# PARKSIDE P.R.U.D. PHASE 1

# THE BRIDGES - PHASE 1

## PRELIMINARY CONSTRUCTION DOCUMENTS EDEN, WEBER COUNTY , UTAH

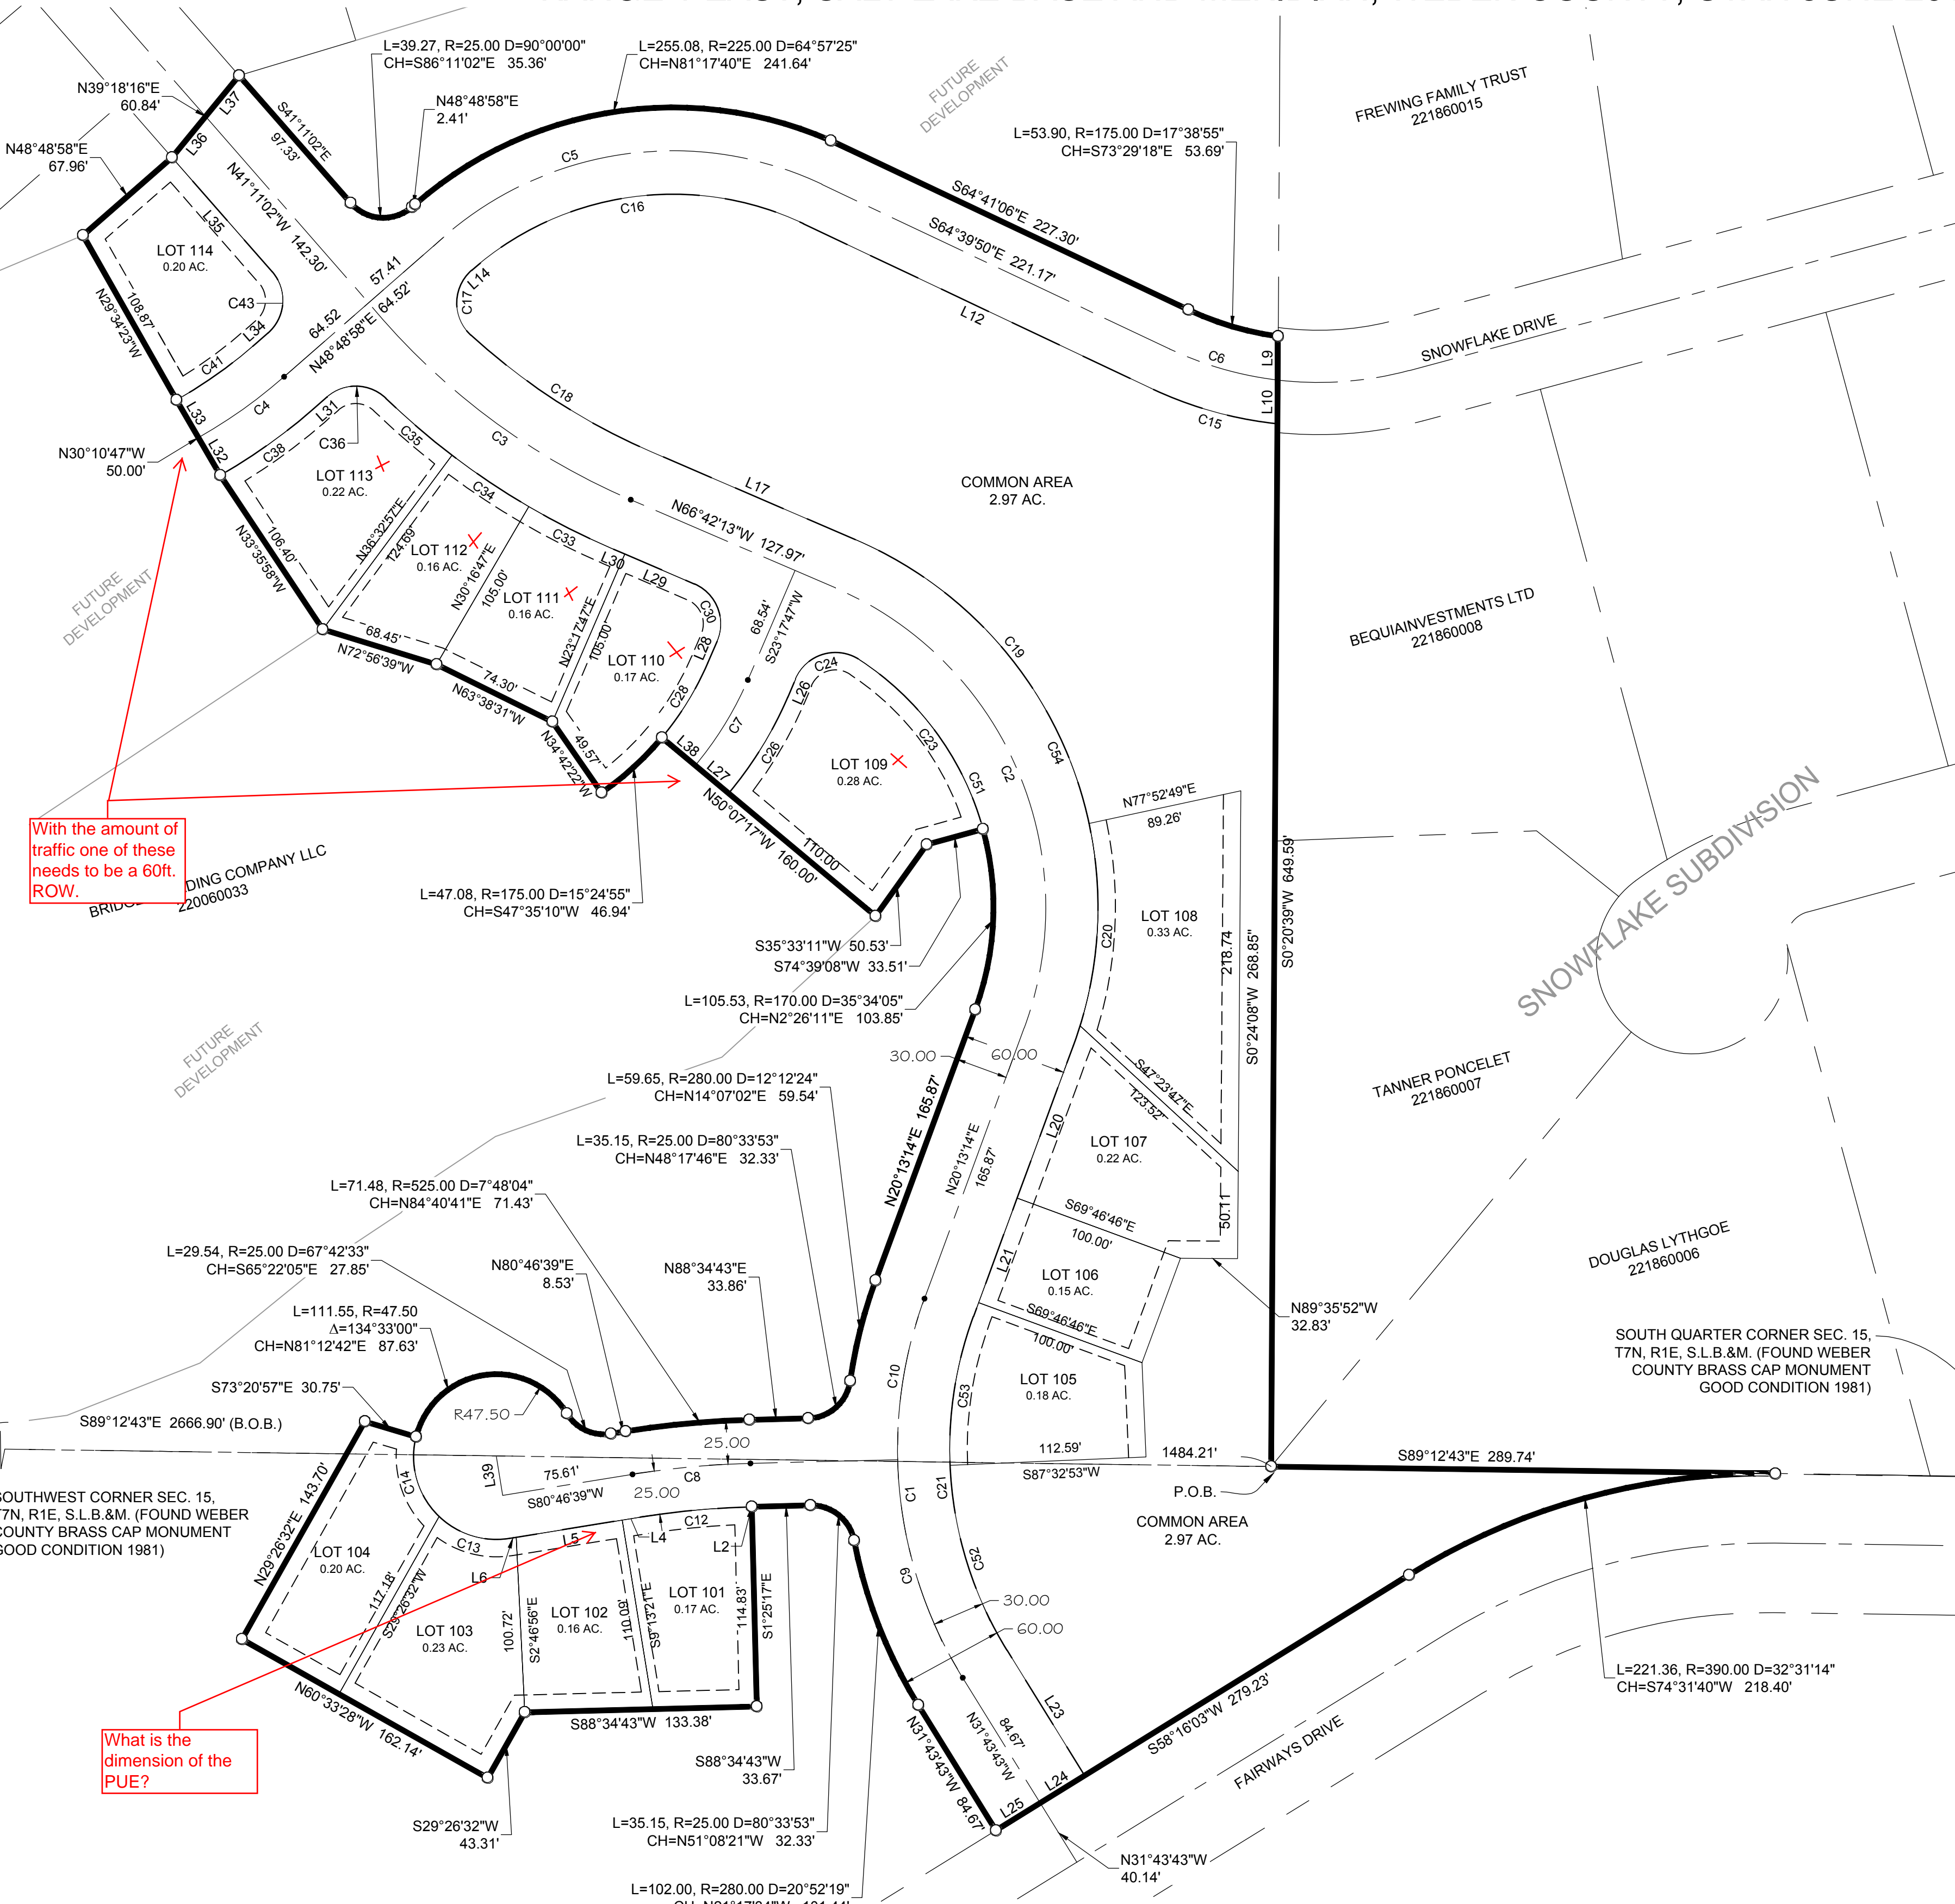
With the amount of traffic one of these needs to be a 60ft. ROW.

What is the dimension of the PUE?

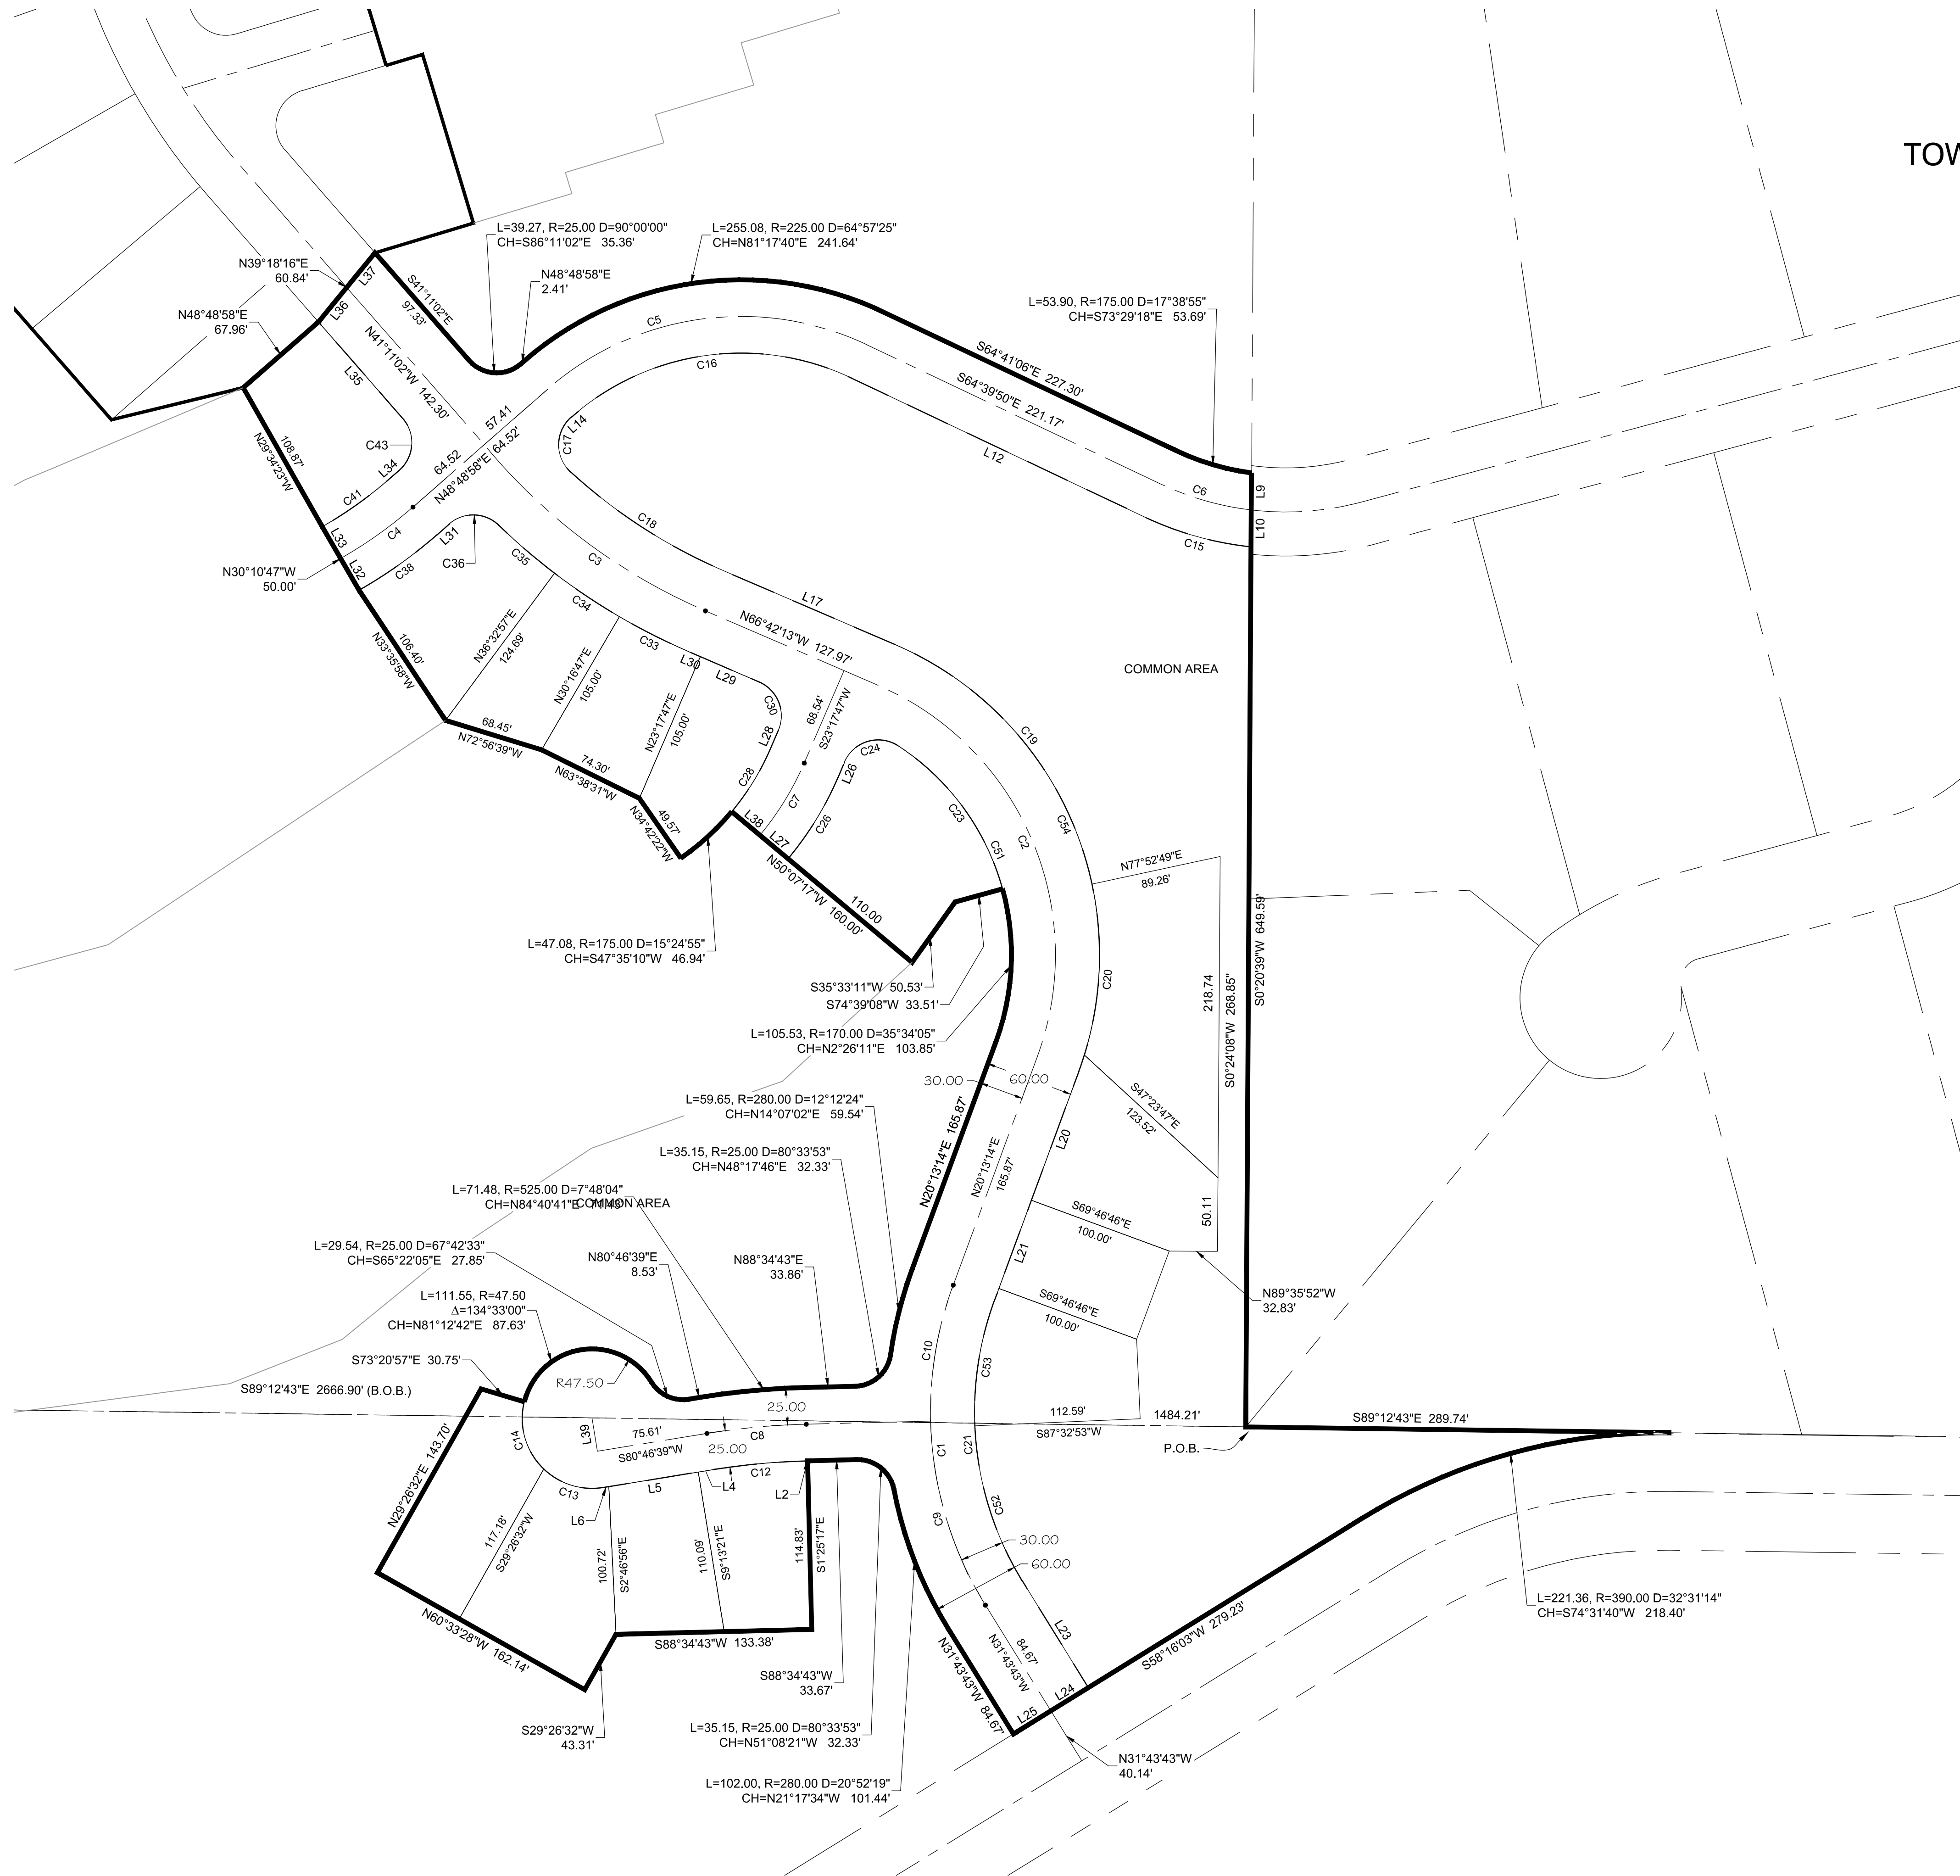
Are there more line #s that are missing??

50' ROW - TYPICAL ROADWAY

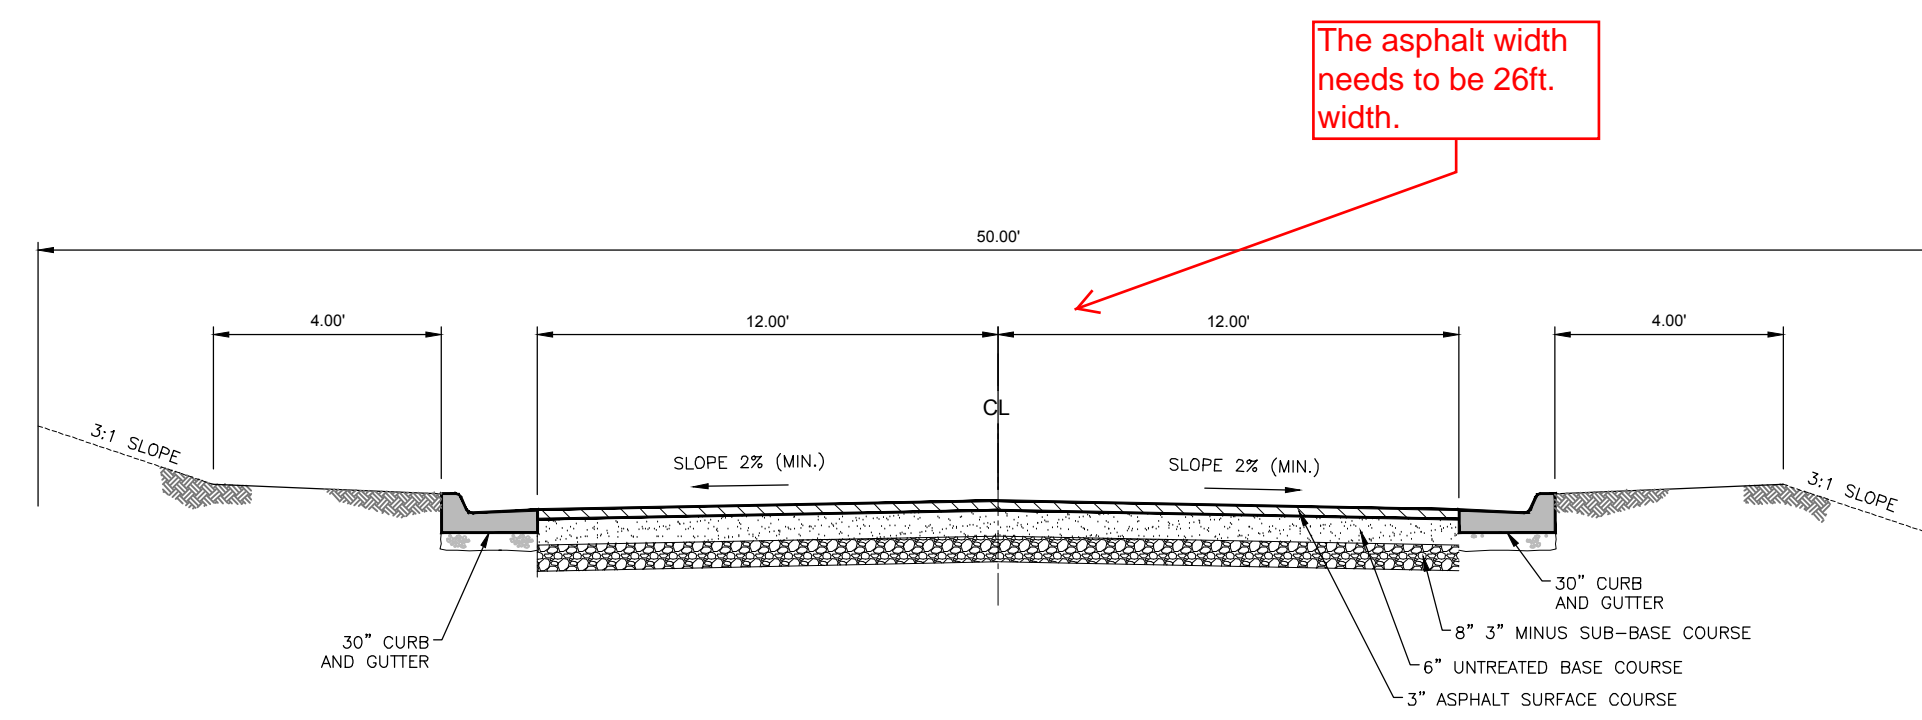
The asphalt width needs to be 26ft. width.

50' ROW - TYPICAL ROADWAY NO CURB

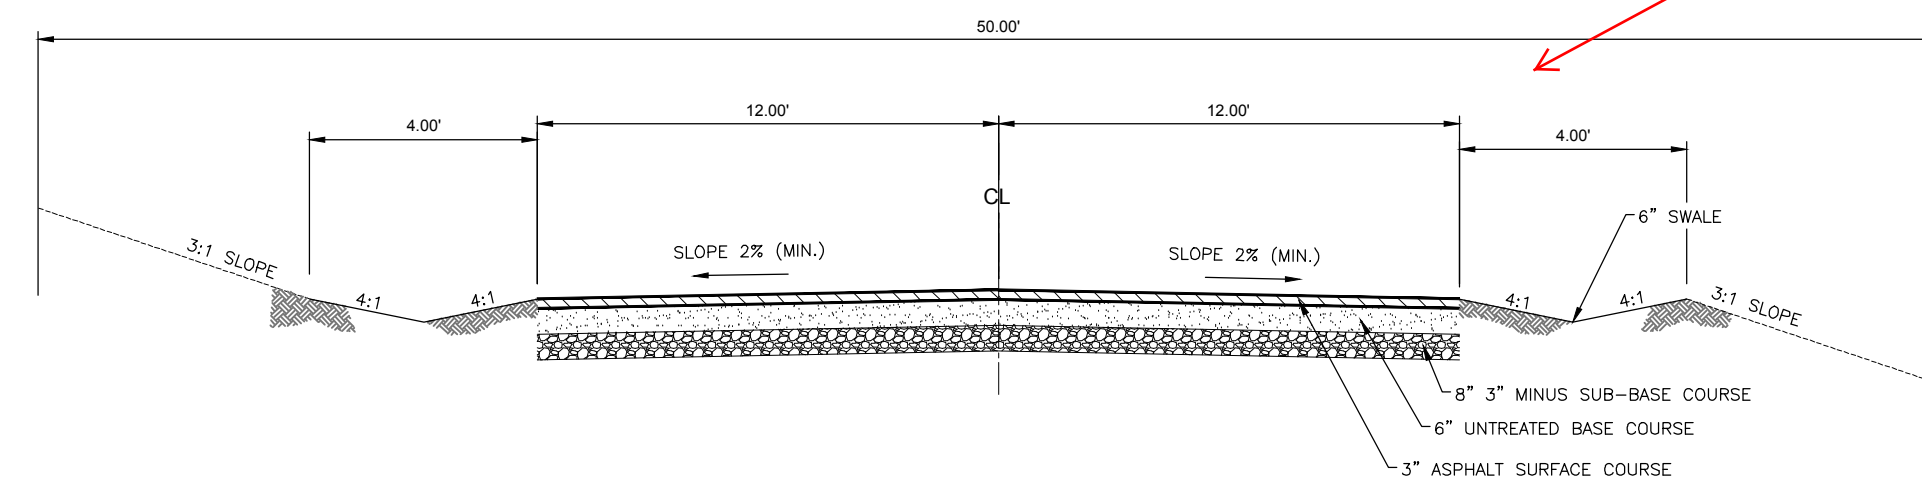
If the rural design is used, in the areas of slopes on the road we would want to see the drainage swale stabilized with some rock and possibly the edge of the road as well to minimize erosion.
